NEW MONKS FARM - LANCING

CONSTRUCTION OF HIGHWAY BRIDGE – HW02 (WSCC REF: 1790)

APPROVAL IN PRINCIPLE

Ref: 14904-HOP-XX-RP-S-0200 Rev. P02

Drawing No. 14904-HOP-ZZ-XX-DR-S-0203 Status D2 Rev. P3

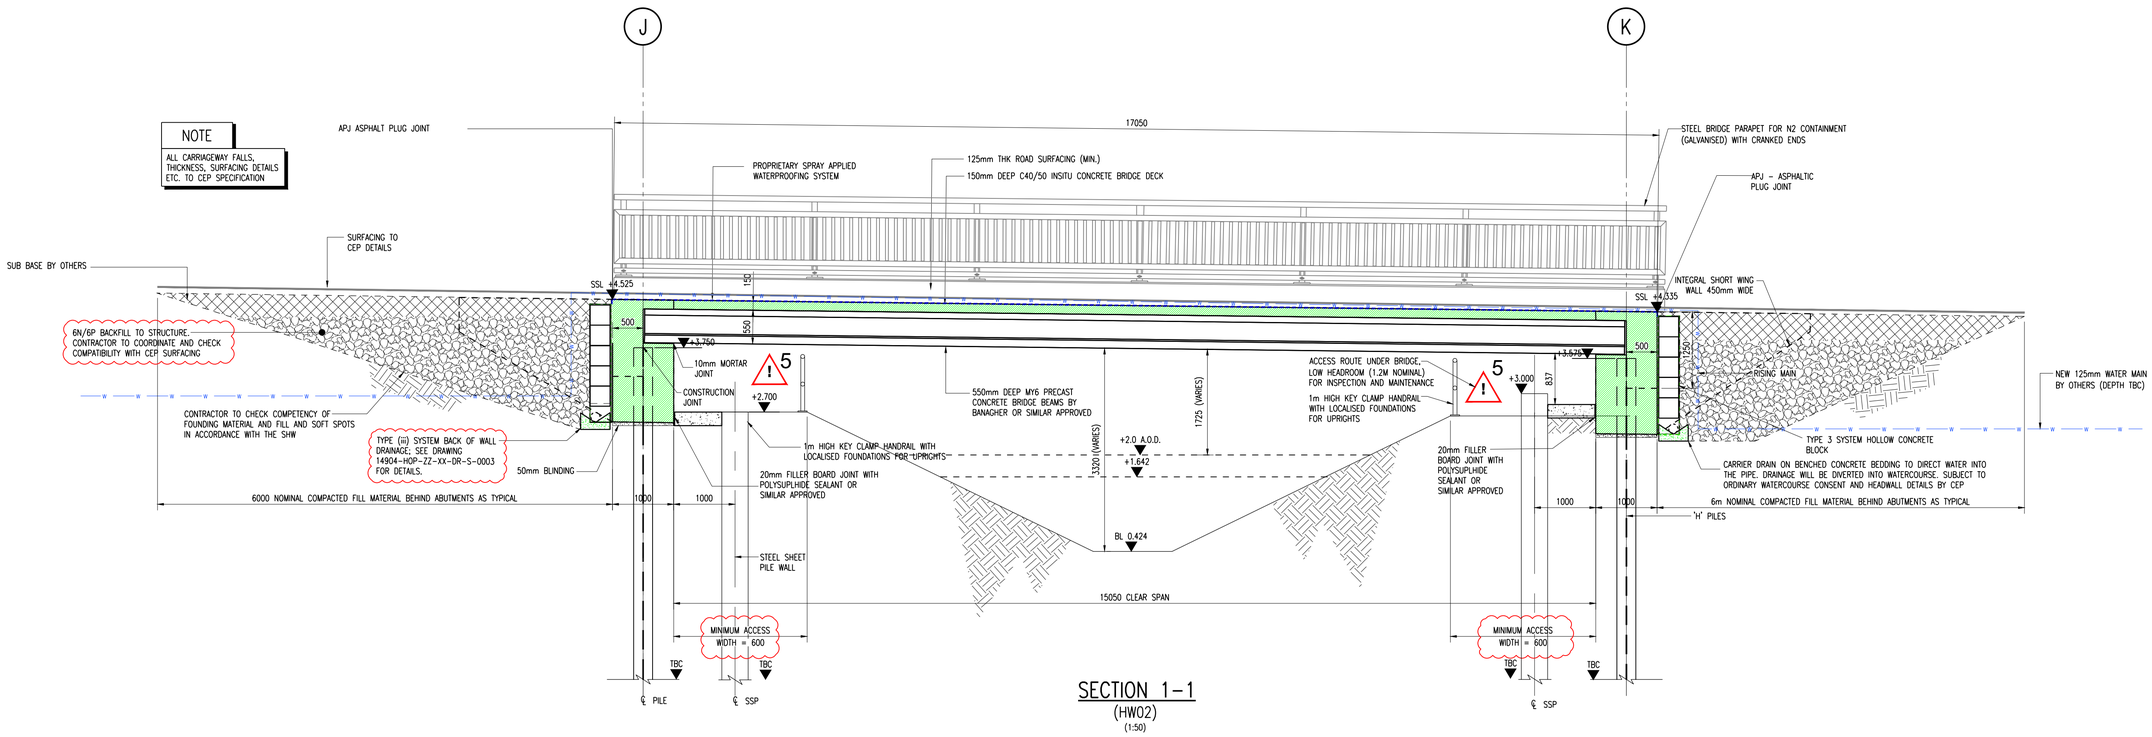
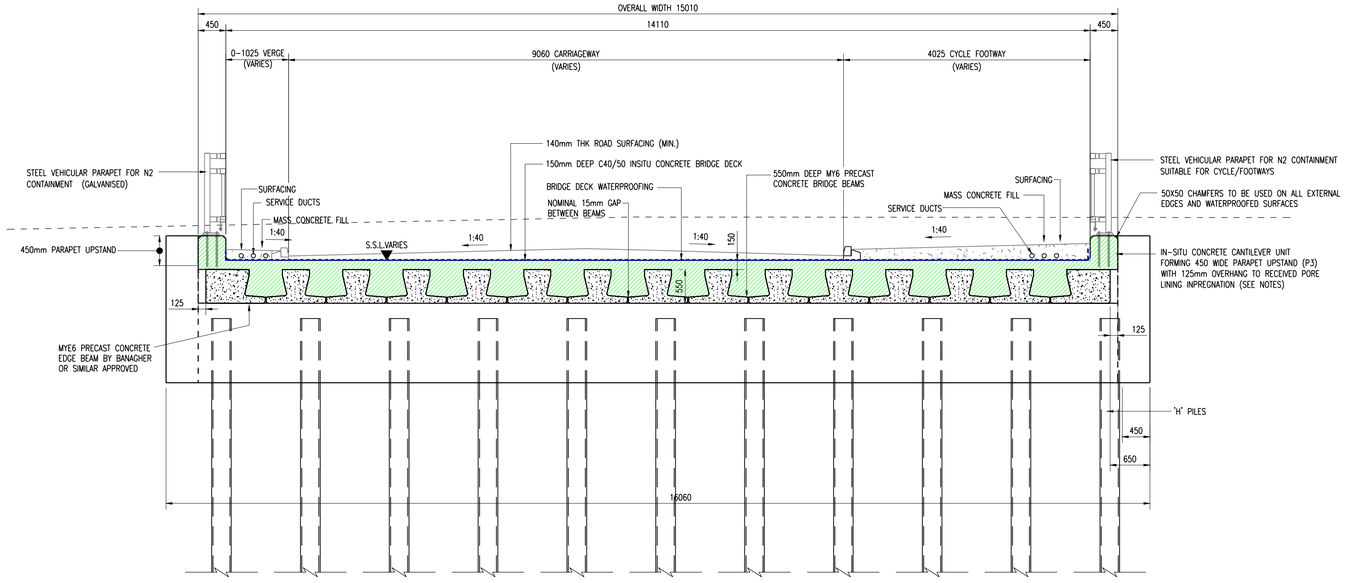
Drg 203 - The drawing currently shows service ducts in mass concrete. It is accepted that concrete protection is required but it should only be provided at the ducts, elsewhere in the verge construction granular fill is required.
